PROPOSED CHANGE NO. SC-01-002R1

Date: July 24, 2025
File: 9.1.7.4.2_SC-01_PC
Project No.: 2215C
Project: TA Blakelock HS Reno - Phase 3
Subcontract: SC-01 General

Description: Elevator 2 (drama area)

CONTEMPLATED CHANGE NOTICE No. S1

2215-C A100

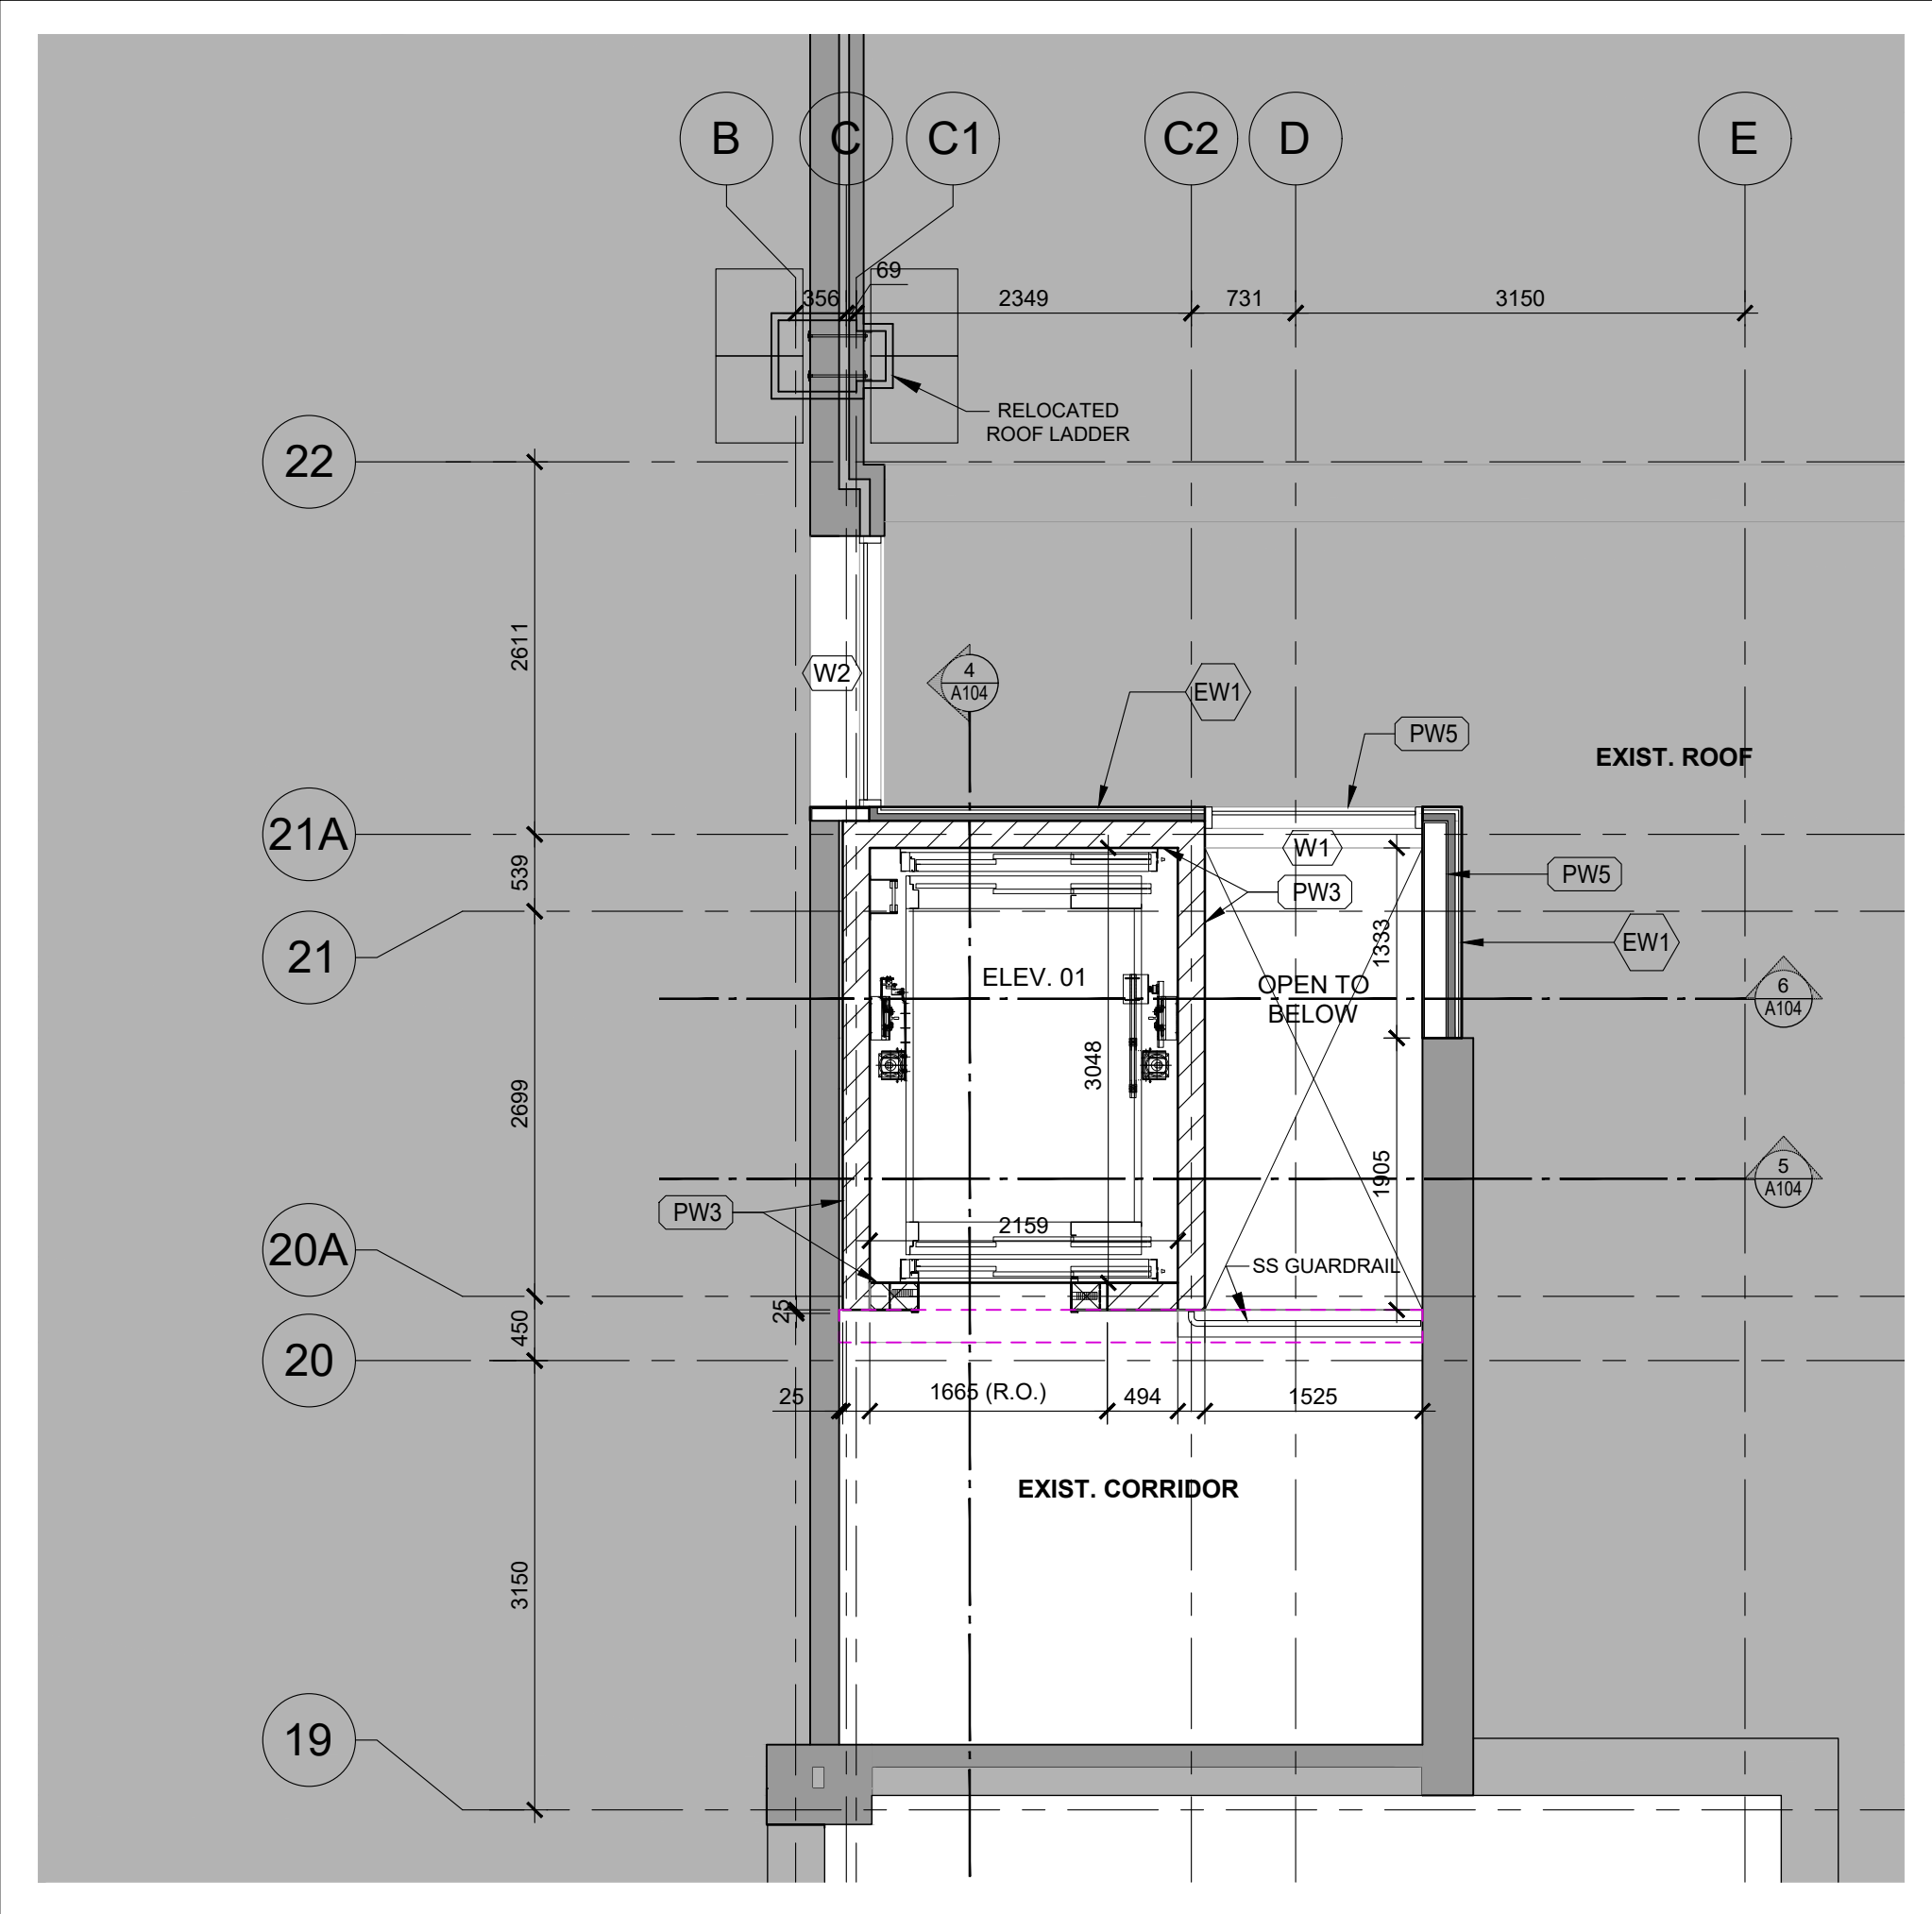
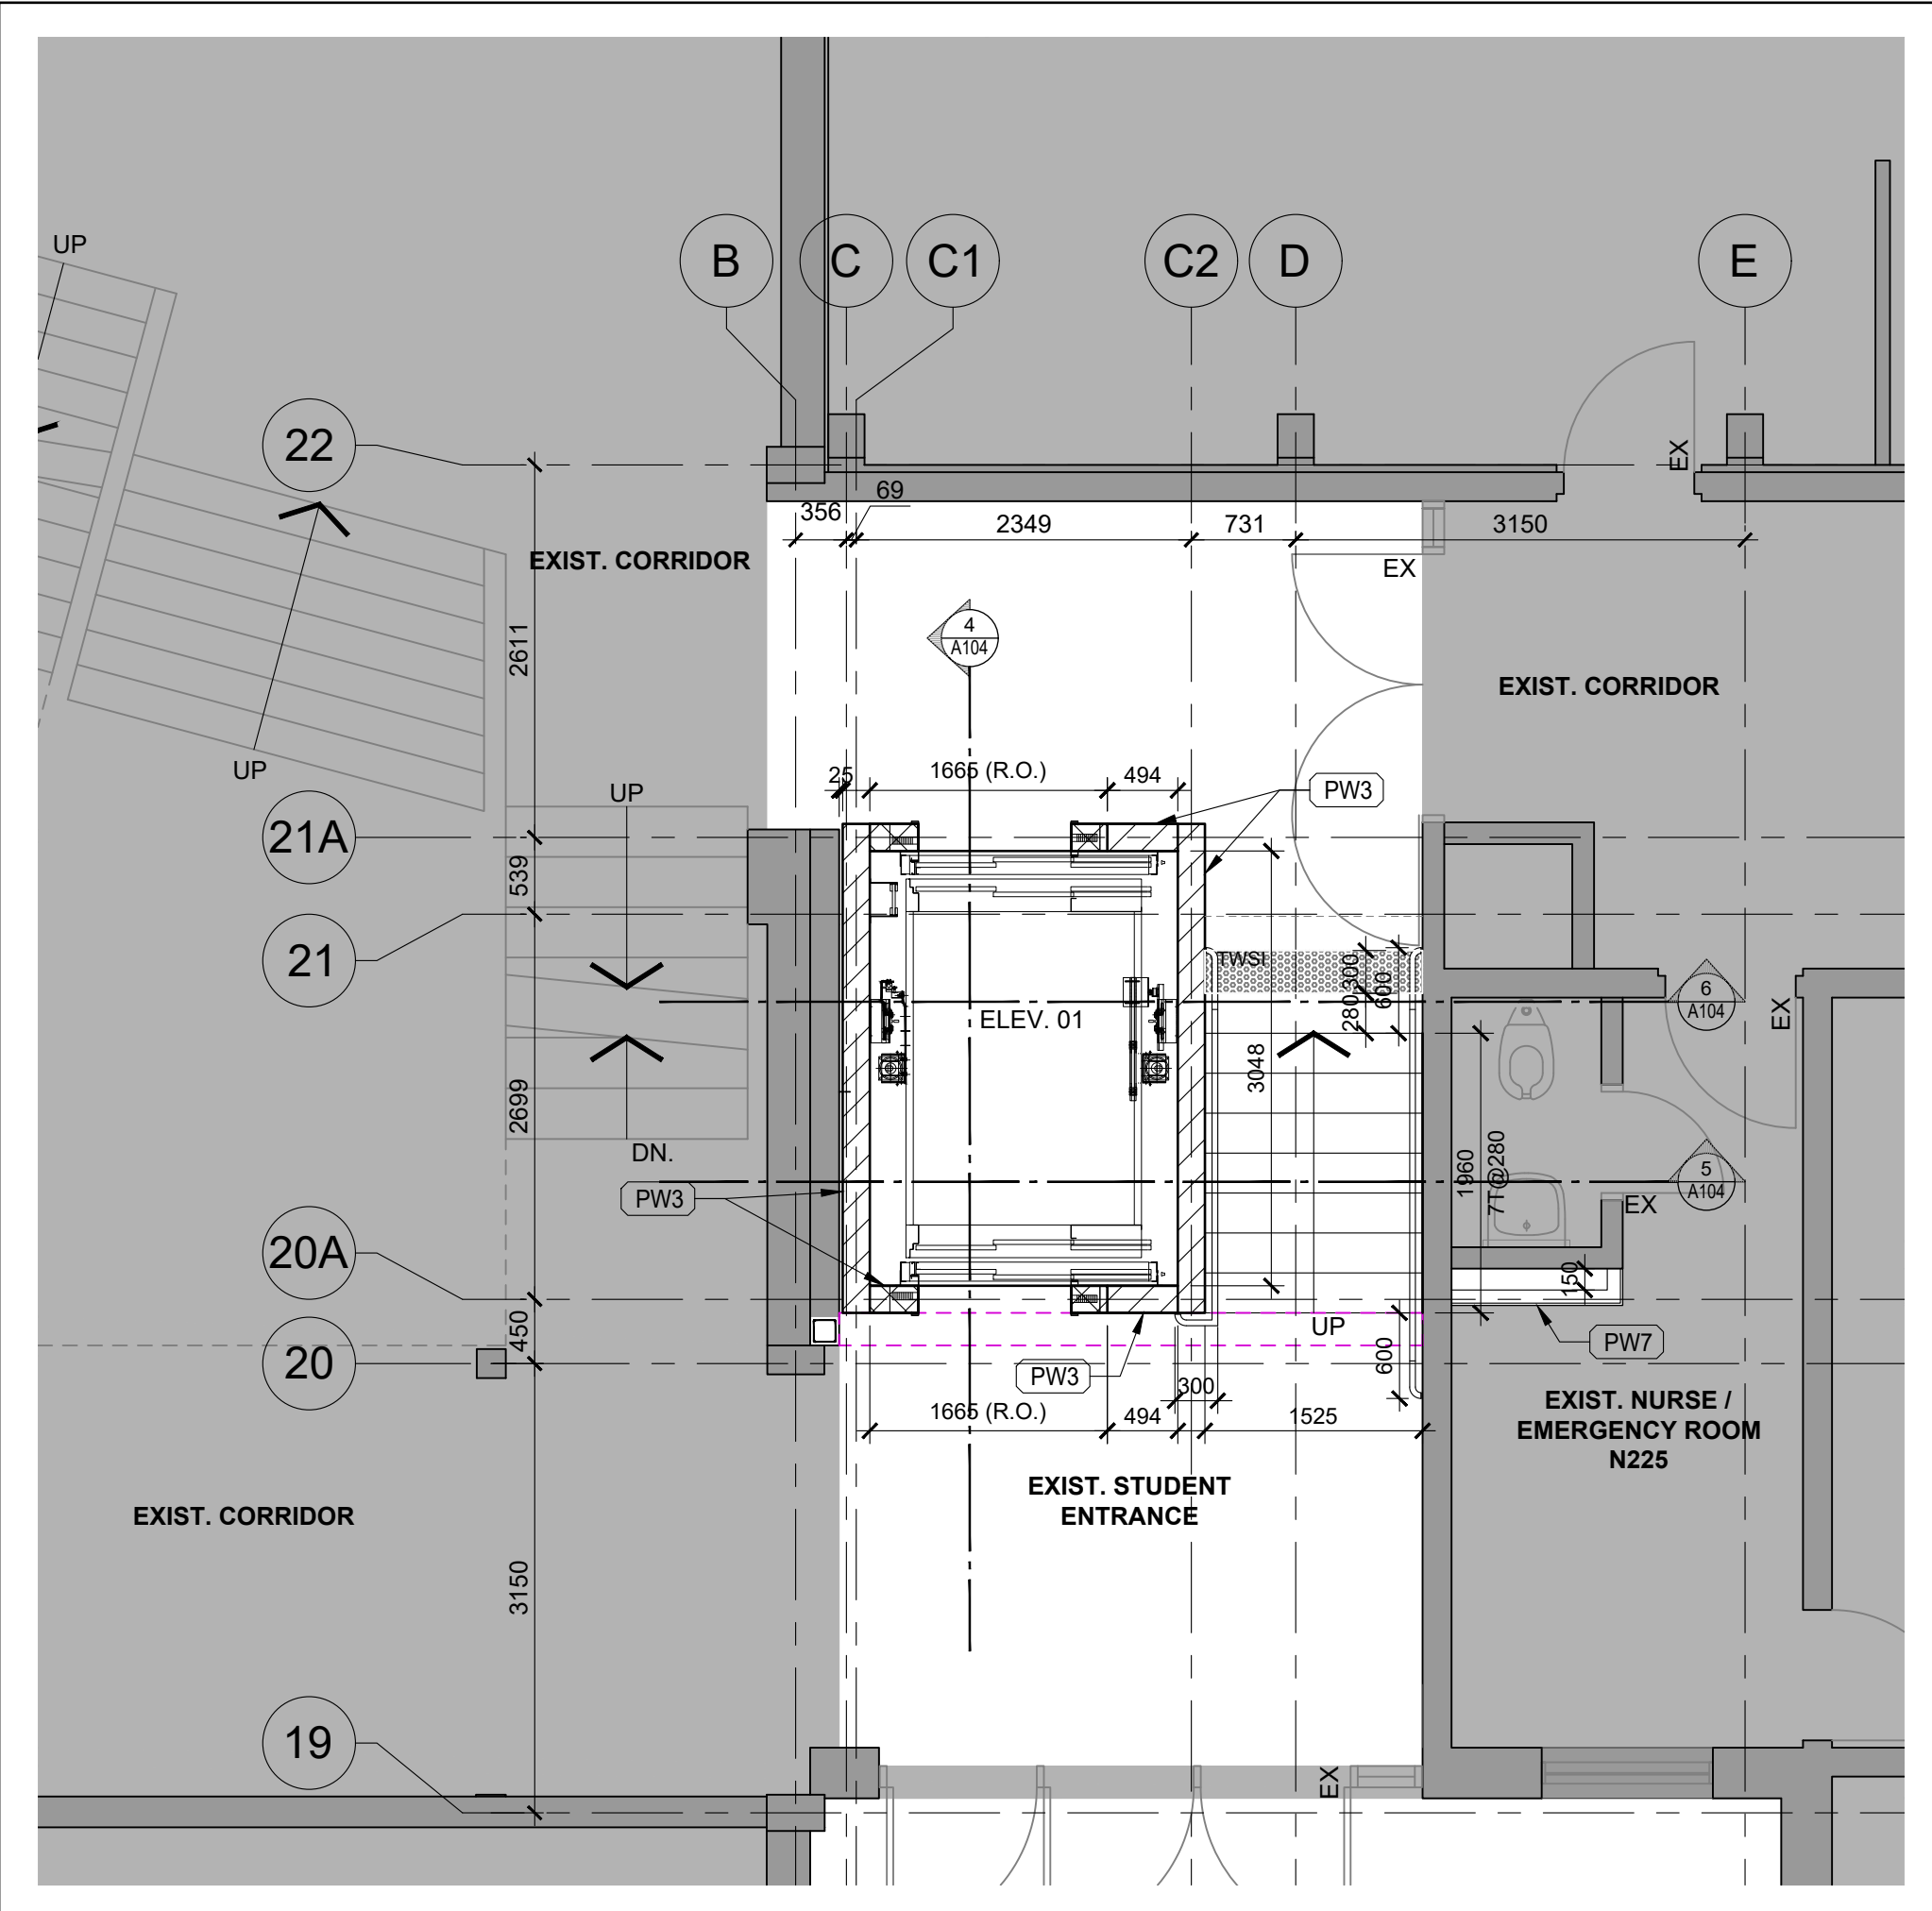
1. Refer to attached updated A100 floor plans and A104 updated sections.
2. Refer to Structural CONTEMPLATED CHANGE NOTICE No. S1 item 1 for requirements.
3. Mechanical CCN to follow adjusting sump pit location and corresponding drainage and piping to it. Electrical CCN to follow confirm power and control until location for sump pit.
4. Refer namely to sump pit relocation, deletion of underpinning along West side of Drama Room (Refer to Structural CCN for scope).
5. Provide 36x 36 ACUDOR FT-8050 concrete floor door, single leaf, 1" recessed to receive flooring. Provide cut sheet. Note this ACUDOR is intended to clear the 24" dia sump pit including sump pit flange. Confirm with vendor. Set sump pit lid just at u/s of lid opening. Provide cut sheet of ACUDOR. Run sump pit venting and discharge line within adjacent 190mm CMU wall.
